## 1981 FL/FX PARTS ORDER OIL PUMP KIT

PART NO. 26200-81

Figure 1 Correct Gasket, Part No.  
26273-80A

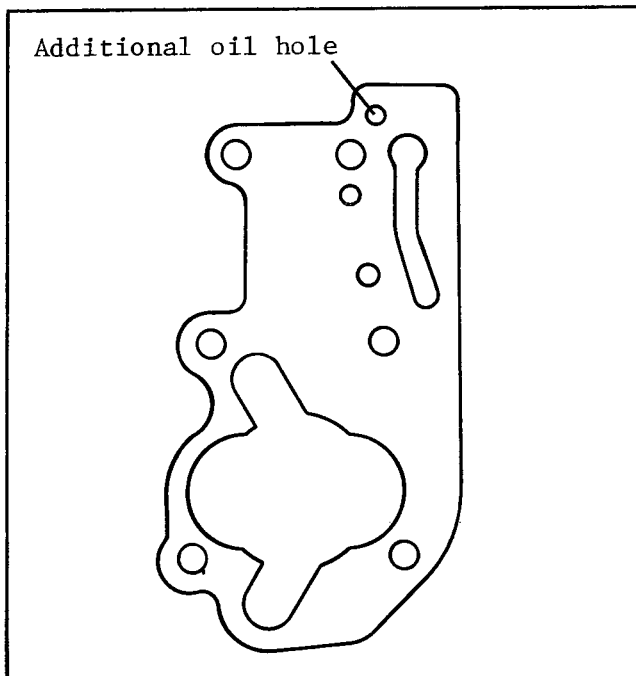
A quantity of 212 1981 OIL PUMP KITS, Part No. 26200-81, shipped before October 10, 1980 contain the wrong pump body gasket. If you have recently received any of these kits, please check them to make sure they contain the correct gasket.

The correct gasket, Part No. 26273-80A, has a raised portion with an additional oil hole at the top of the gasket. See

Please order enough correct gaskets,  
Part No. 26273-80A, to make this change.

Figure 2. Incorrect Gasket, Part No.  
26273-80 (Use with late  
1980 oil pumps only.)

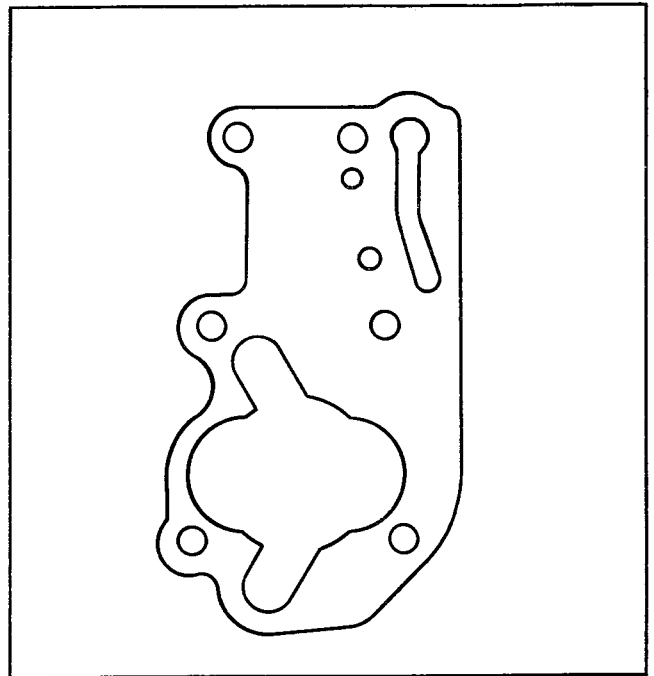
Figure 1. The incorrect gasket, Part No. 26273-80, should only be used with late 1980 oil pumps. See Figure 2. Refer to Service Bulletin M-771 for more information on late 1980 oil pump and gasket changes.
